STAFF REPORT

APPLICATION SE 2011-HM-019

APPLICANT: Coresite Real Estate 12100 Sunrise Valley Drive, LLC

PROPOSAL: The applicant requests approval of a special exception to permit an increase in floor area ratio to 0.7 to allow for the construction of a new data center building adjacent and connected to the applicant's existing building and associated modifications and waivers.

LANDSCAPE PLAN

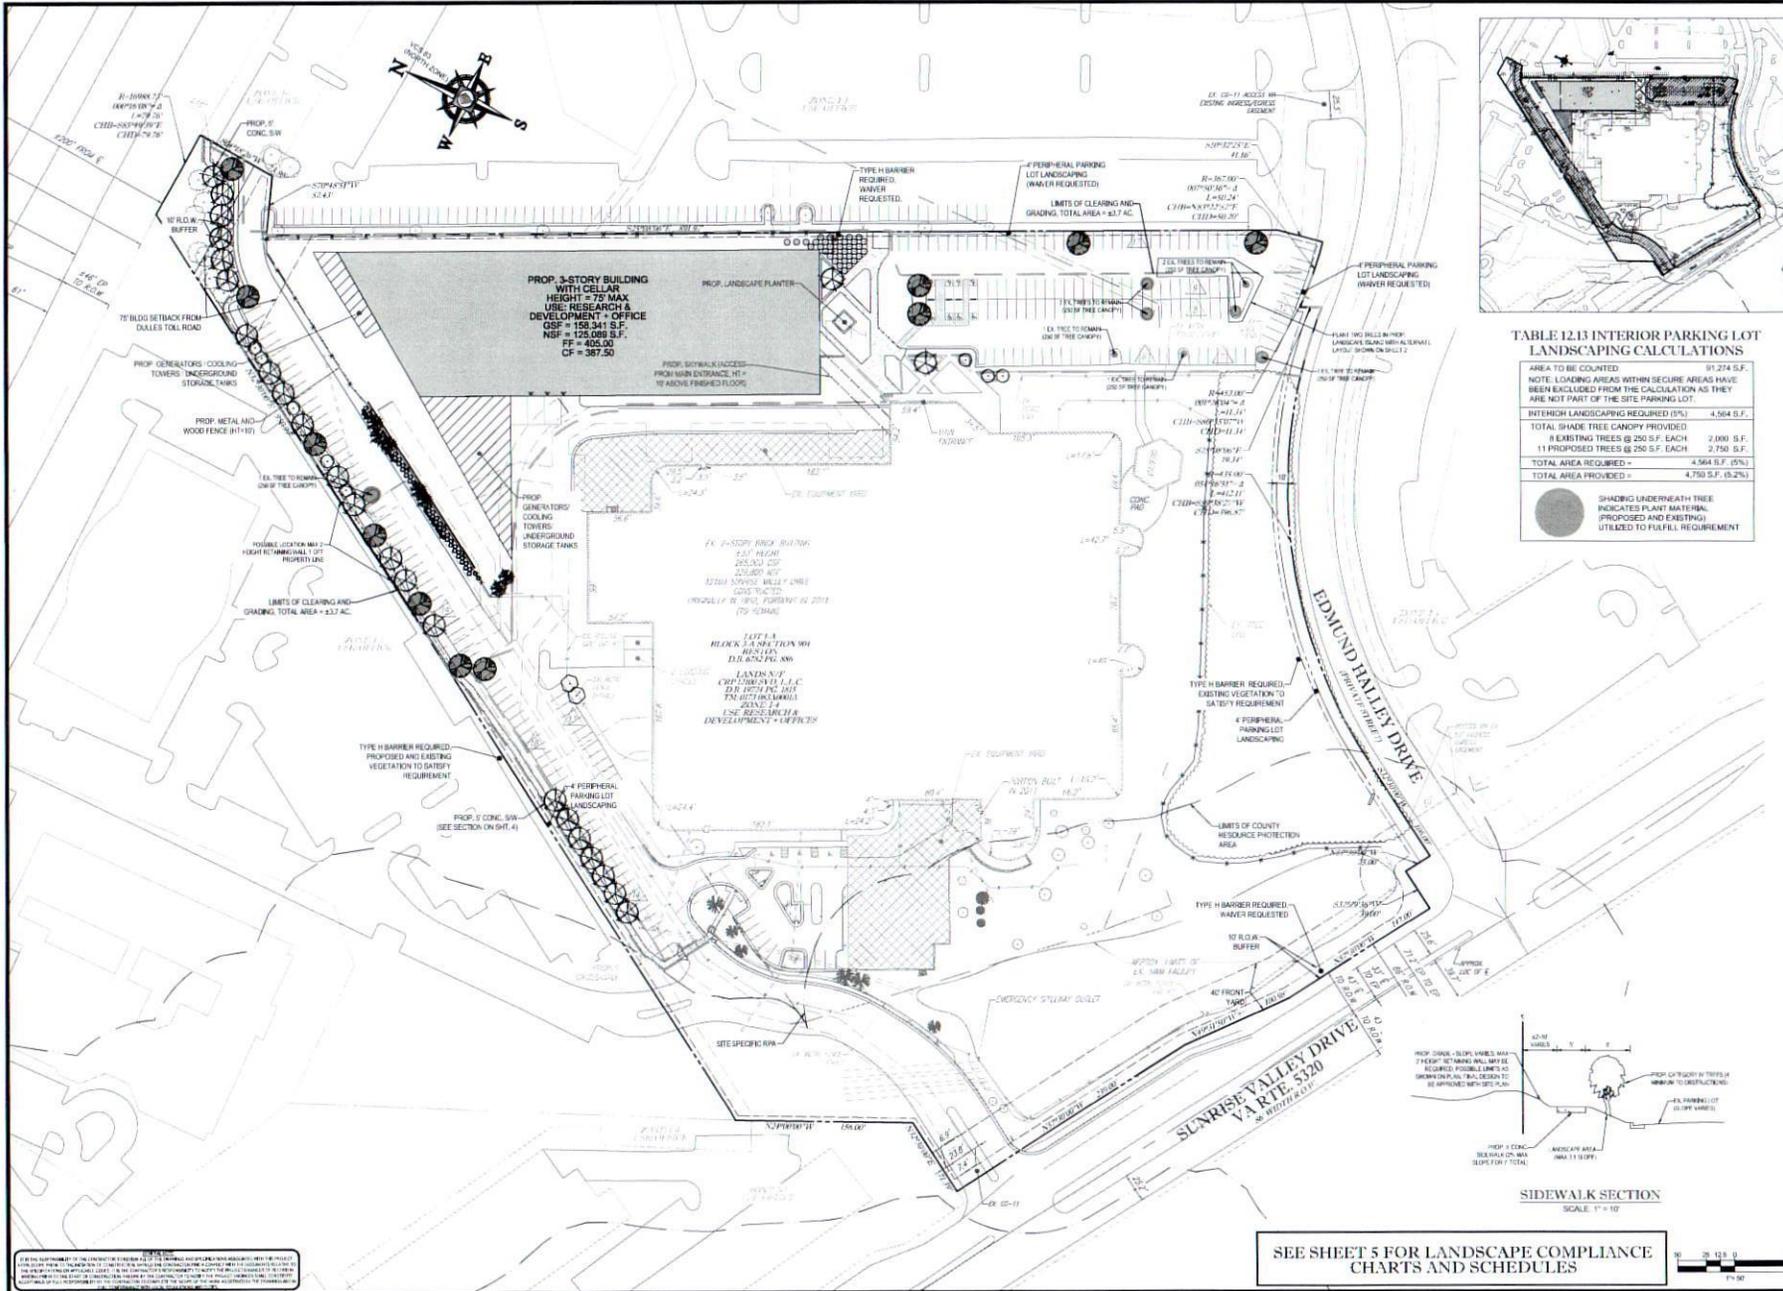
The Urban Forest Management Branch of DPWES reviewed the application and had several comments related to the interior parking lot landscaping, peripheral parking lot landscaping, tree canopy credit, and planting details.

In the original plan submission the applicant was claiming credit for trees in poor condition and for proposed trees not located in the parking area, as defined in the ordinance. As shown, the proposal did not meet the interior parking lot landscaping standards.

The plans showed numerous trees being used to meet the tree canopy credit requirement located within four feet of a building or other barrier. The PFM

The applicant has revised the landscape plan to properly identify those trees that will actually shade the parking spaces in the interior of the parking area. The revised submission includes additional new trees sufficient to meet the ordinance requirements. The plan has been reviewed by the Urban Forester and has been deemed satisfactory.

In consultation with the Urban Forester, the applicant revised the planting plan to correctly identify the area where peripheral parking lot landscaping is required. Additional trees were added adjacent to the northeast corner of the proposed building. The revised plan has been reviewed by the Urban Forester and has been deemed satisfactory.

The applicant has revised the location of any trees being included in the tree canopy credit calculations to be at least four feet from all barriers. The issue has been satisfactorily resolved.

SHEET NUMBER: 5 OF 6

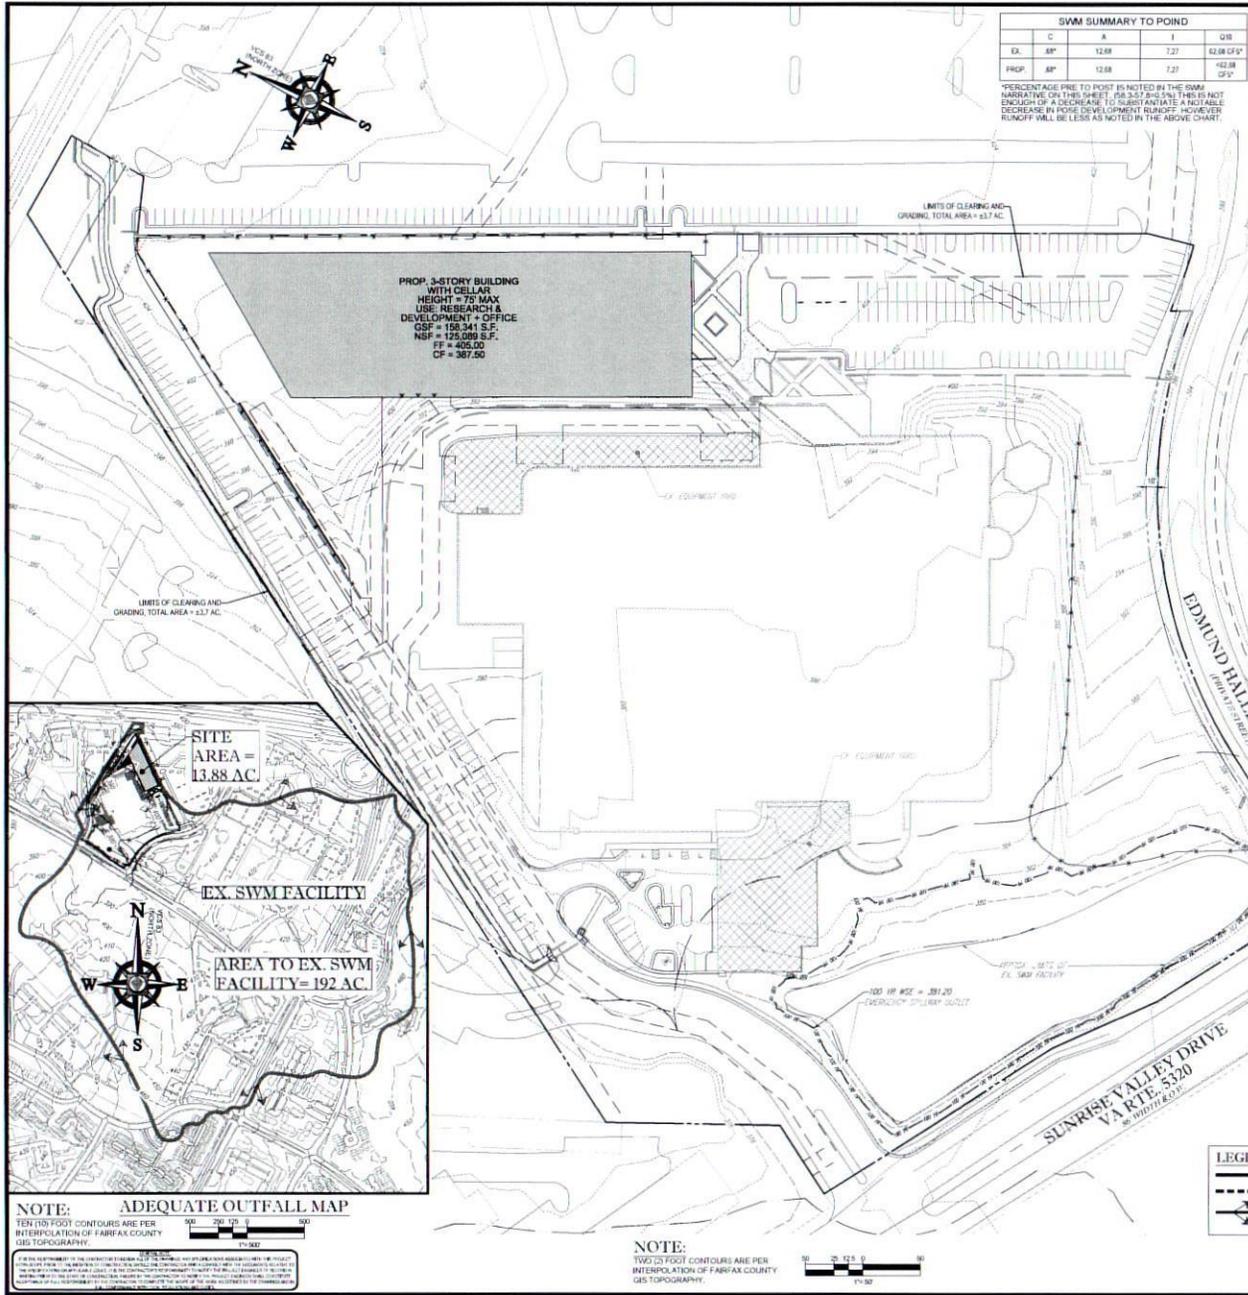
In the most current plan submission, the planting legend on Sheet 5 contains errors in the credit being claimed for the types and sizes of trees listed.

A development condition is proposed that will require final approval of the tree canopy calculations by the Urban Forest Management Branch at that time of site plan review. With this condition, staff believes this issue has been satisfactorily addressed.

Figure 4. Overlay showing conflict between original proposal and conceptual tunnel alignment.

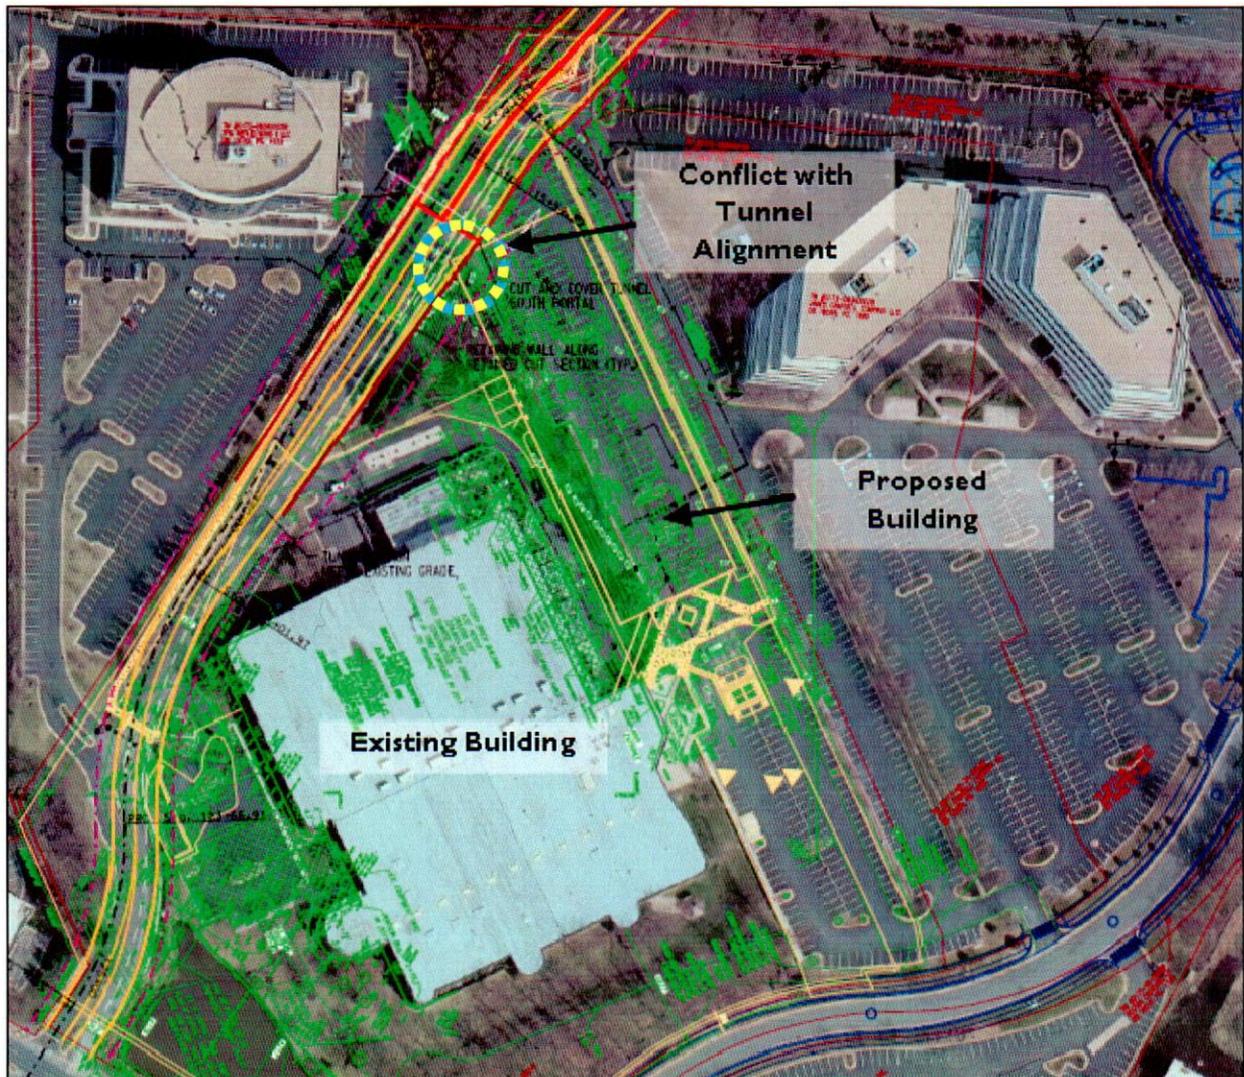
While the comprehensive plan conceptually shows this crossing just to the east of the subject site (utilizing Edmund Halley Drive), final engineering plans for the kiss-and-ride at the Town Center Metro Station have made that alignment infeasible. FCDOT studied a number of alternatives and subsequently developed a preferred alignment that would run under the DTR and along the western side of the subject site. Preliminary engineering drawings, including necessary ROW and construction easements, revealed that the new roadway would conflict with the northwest corner of the proposed building (see Figure 3).

As discussed in greater detail in the land use analysis section above, the location of the proposed building as depicted on the original submission was located within the possible alignment of the Town Center Parkway extension across the Dulles Toll Road. Preliminary engineering analysis showed the northwest corner of the building in direct conflict with the required future right-of-way.

After a series of negotiations, the applicant agreed to shift the northwestern wall of the proposed building approximately 45 feet to south and east, out of the area identified for the potential tunnel alignment. The applicant has stated that they would be willing to dedicate any necessary right-of-way at such time in the future that the subject property redevelops and is no longer used as a data center by Coresite; however, there is no formal commitment to ensure this will occur. Additionally, the applicant has agreed at this time to reserve a small portion of right-of-way along the northern property line to facilitate a future east-west connection and future development of a grid of streets in this area. A development condition has been proposed to memorialize this commitment. With the shifting of the building outside of the area identified for the tunnel alignment and the imposition of these development conditions, staff believes the applicant has minimized the potential effects of the development of the future crossing based on current projections and Comprehensive Plan guidance.

After a series of discussions with the applicant, they agreed to relocate the northeastern building wall approximately 45 feet to the southeast and to redesign the proposed footprint to avoid any direct conflict with the conceptual roadway location. The latest revised SE plat dated May 15, 2012, reflects this change. This addresses staff's concerns to the extent possible given current information about the future roadway.
